Date • 4/20/2026  
Project No. • 2024-DC048-002

Project • Henry Wade JJC  
Air Handler Replacement

**The following describes the Addendum Content - DRAWINGS**

M6.01

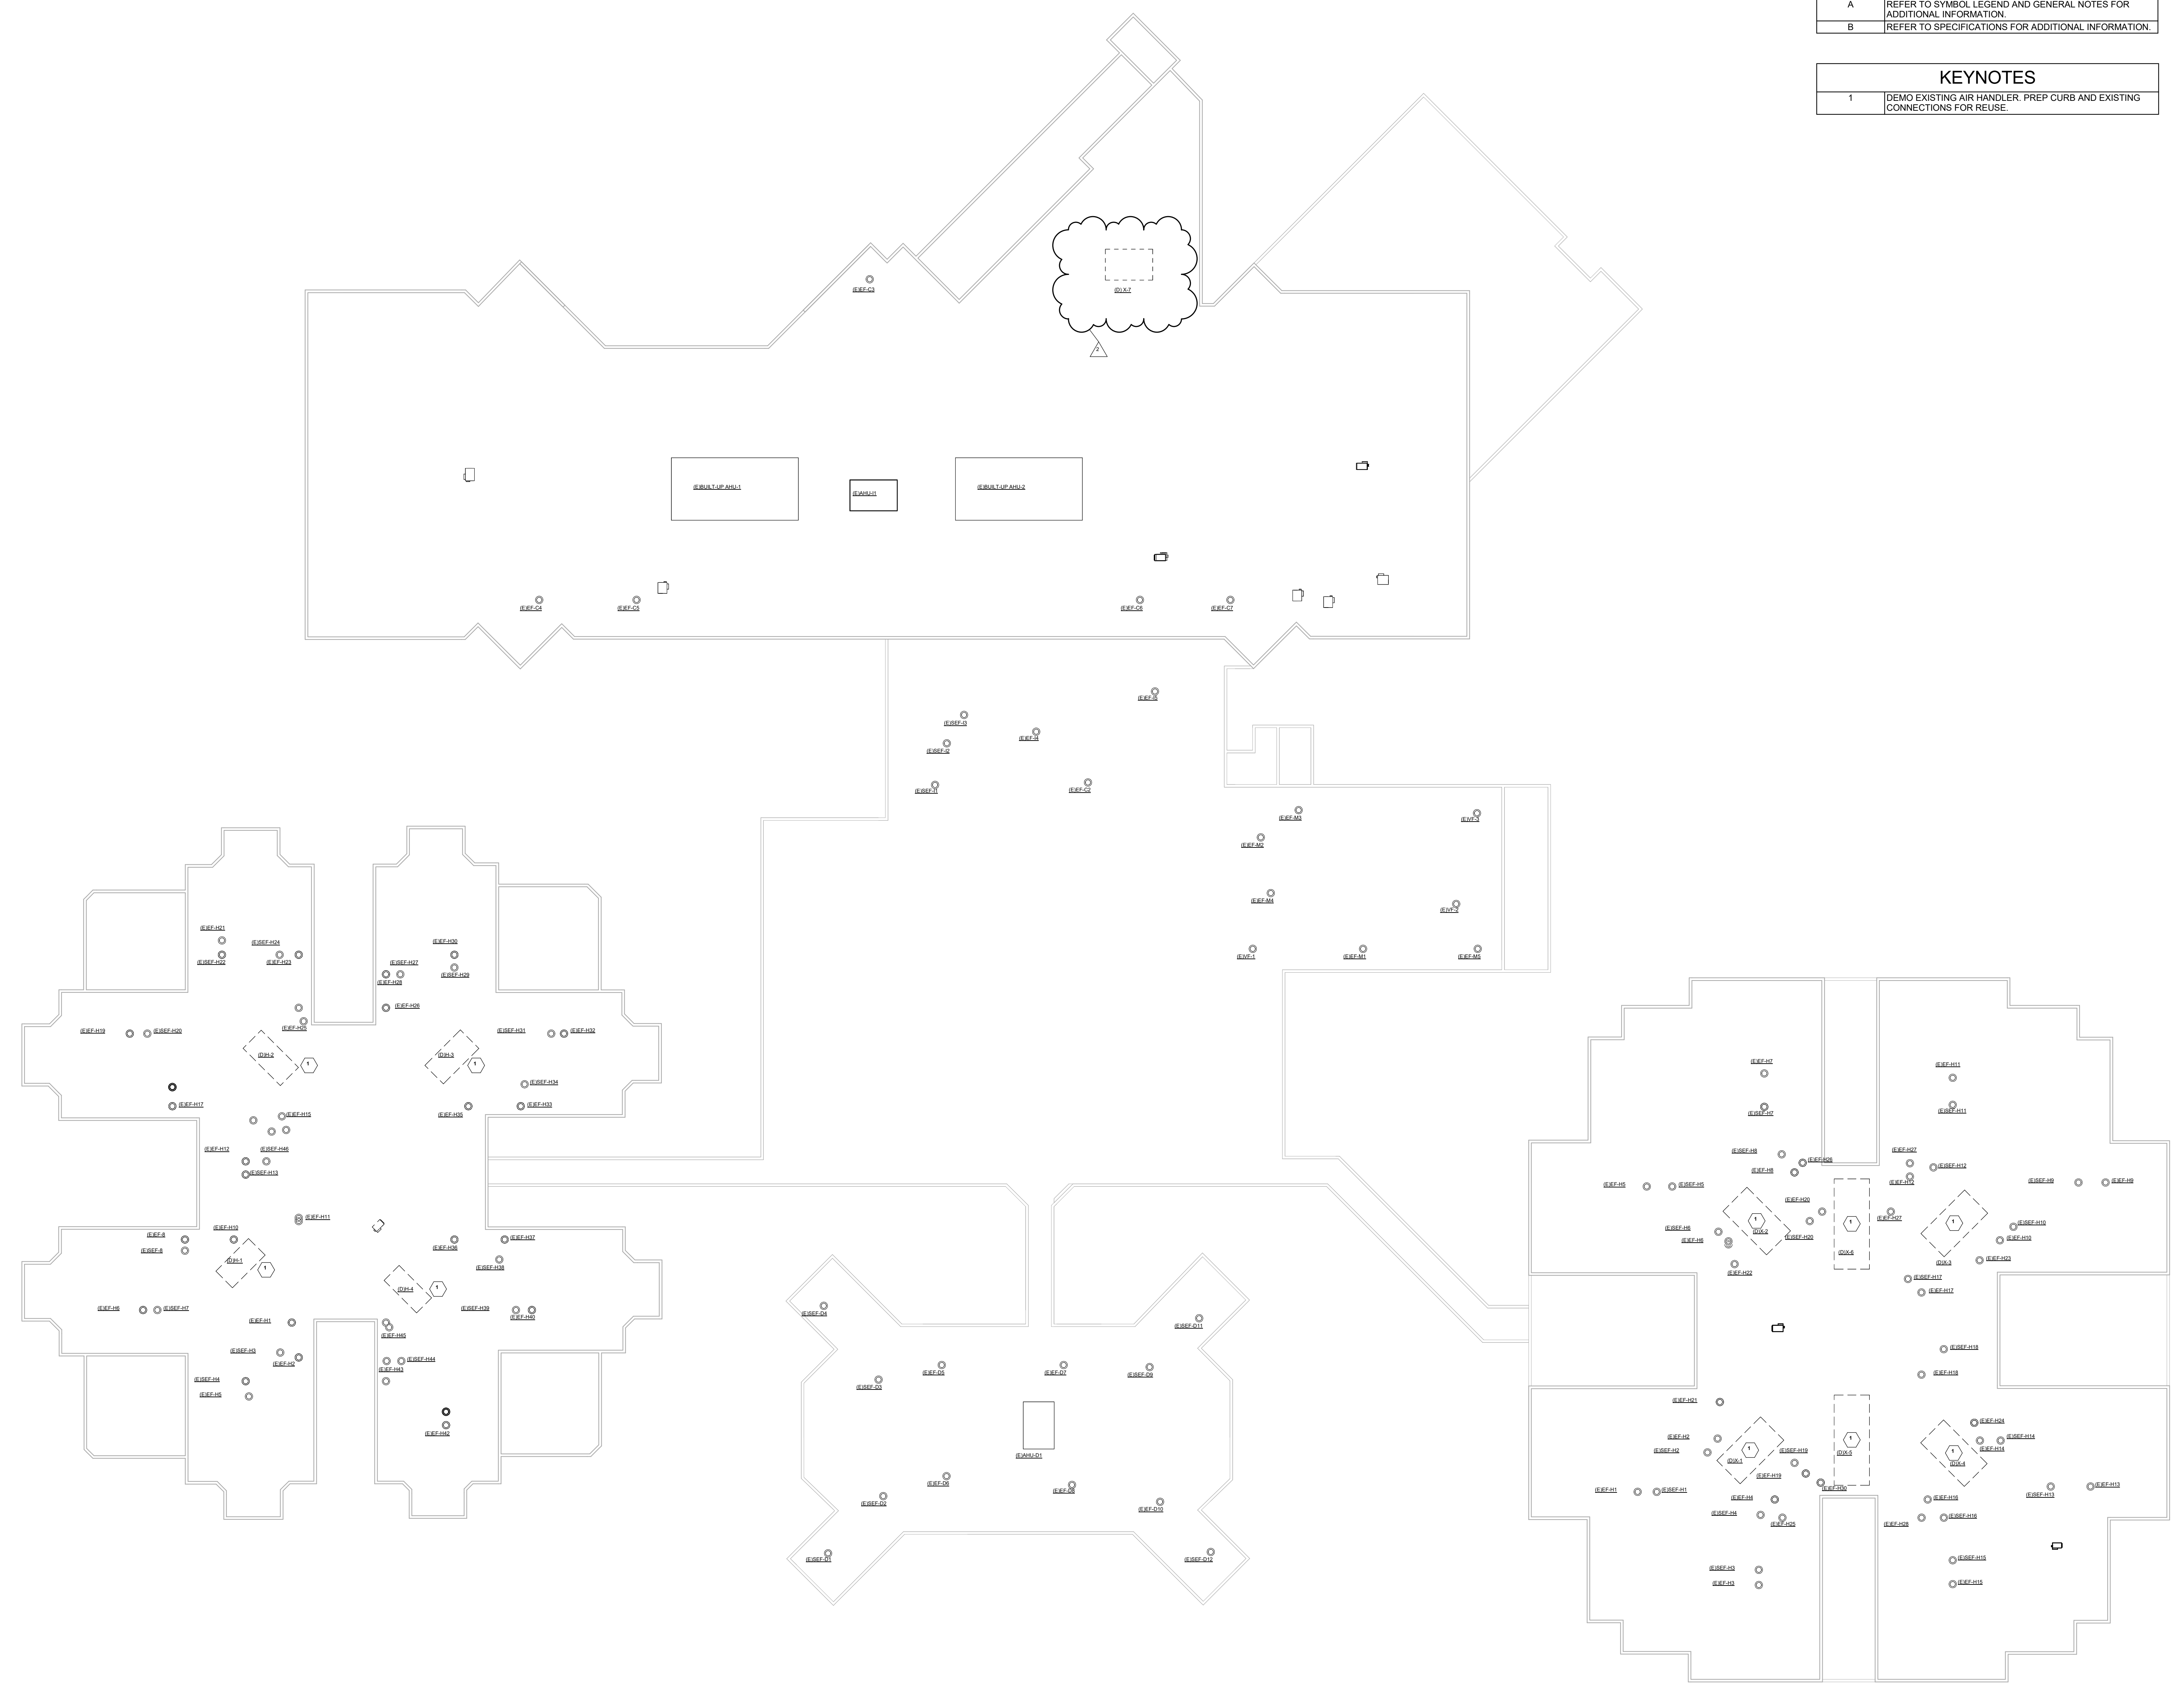
Sheet M6.01: Added graphic of unit X-7 (demo).

KEYNOTES	
1	DEMO EXISTING AIR HANDLER. PREP CURB AND EXISTING CONNECTIONS FOR REUSE.

MECHANICAL  
SCHEDULES

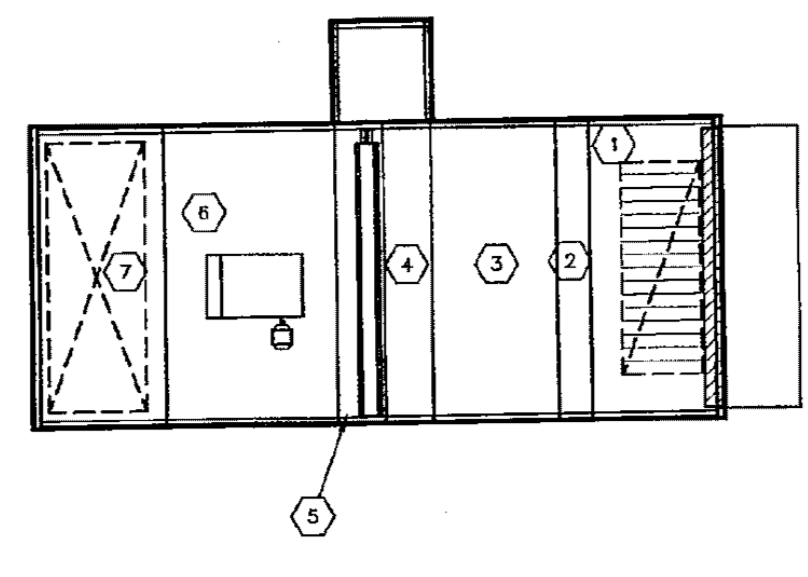
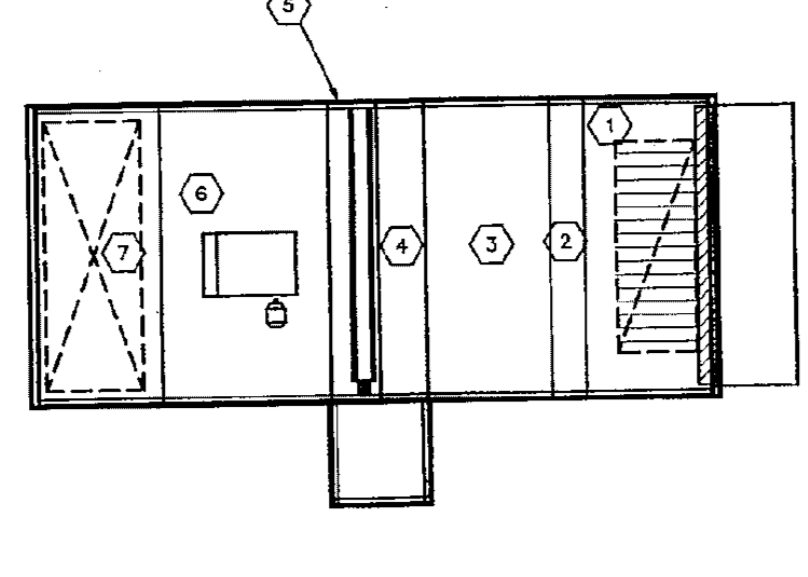
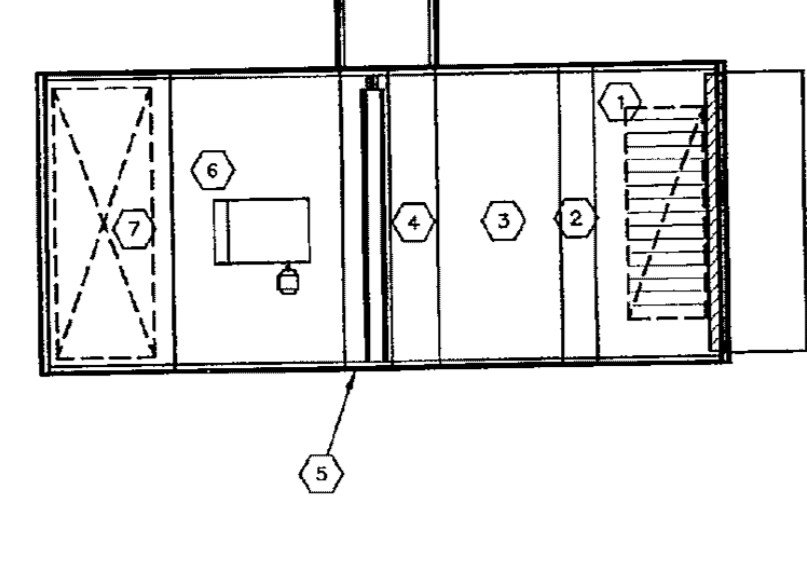
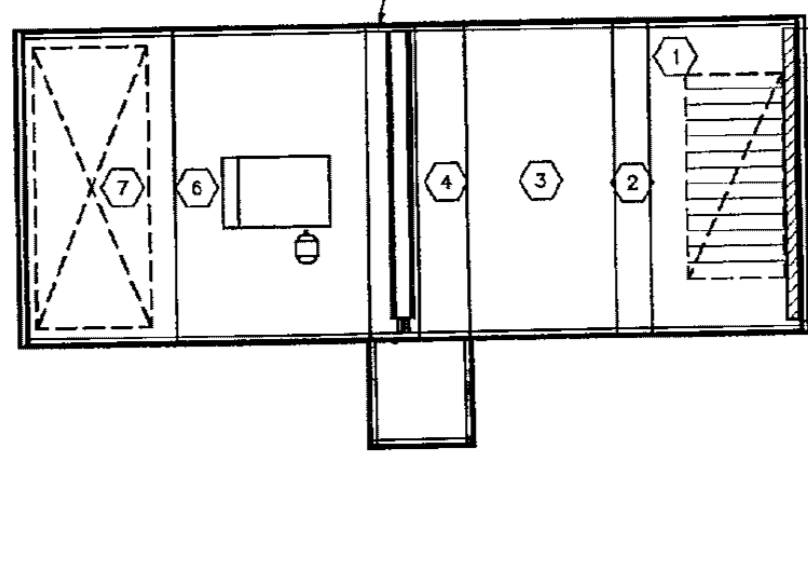
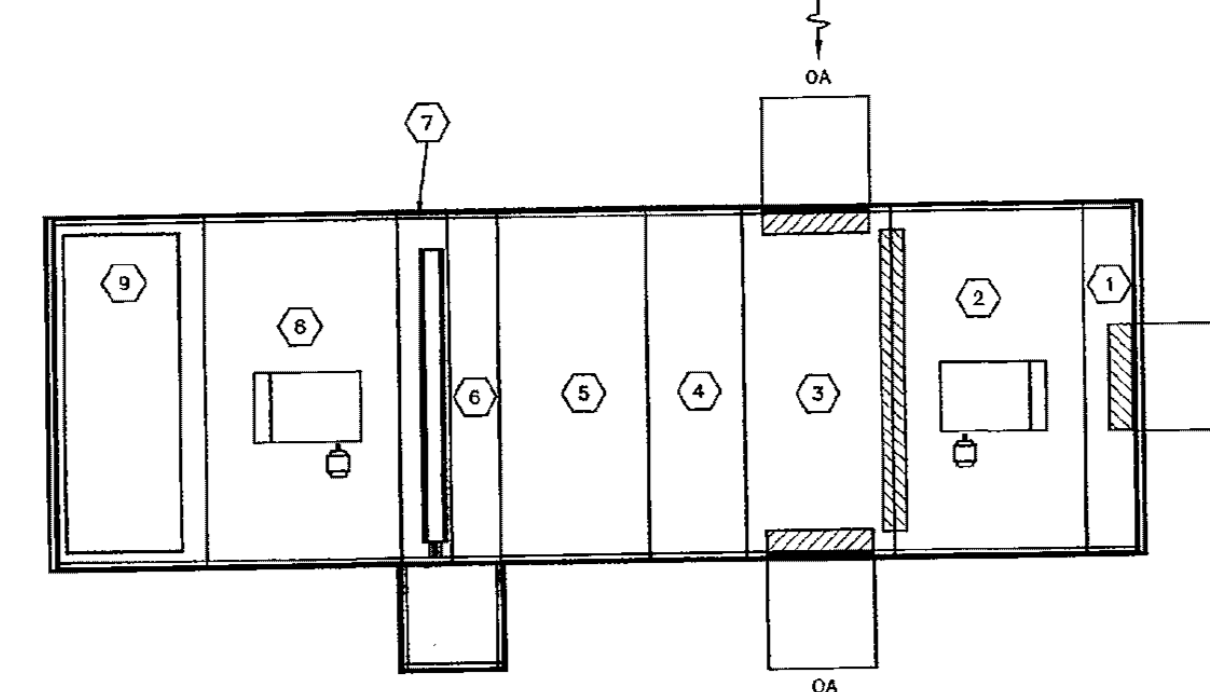
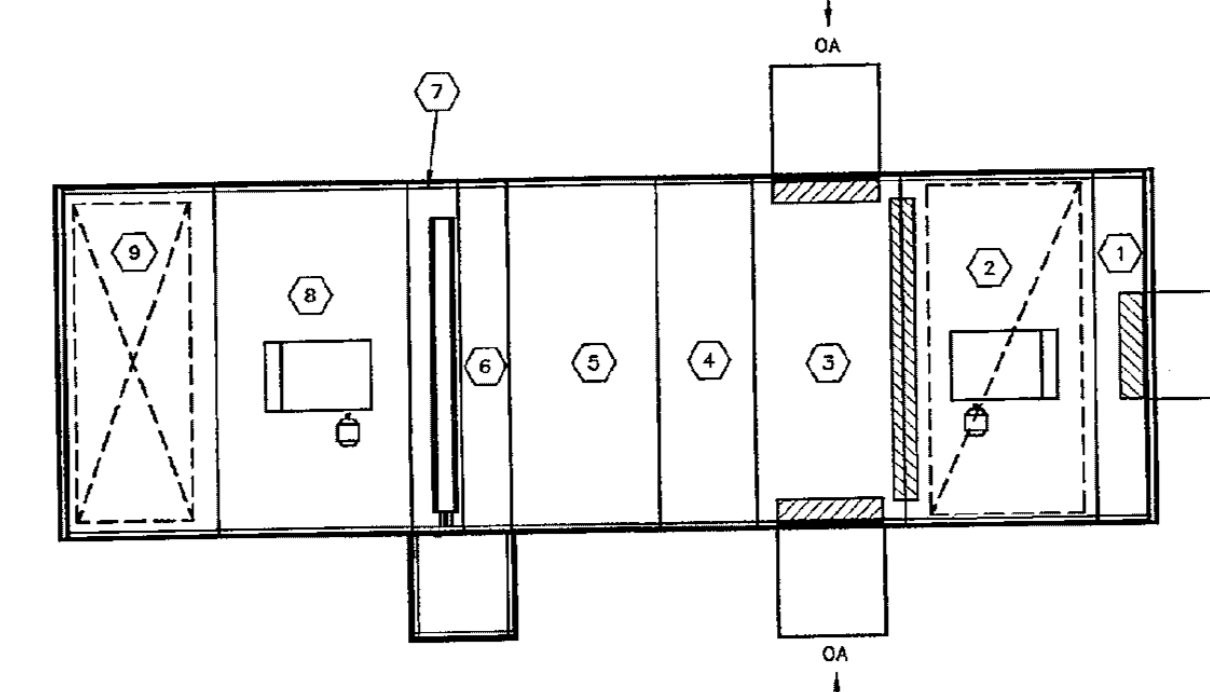
Sheet M10.01: Added generic schedule for Fan Powered Terminal Units.  
Added elevations of AHU for reference.
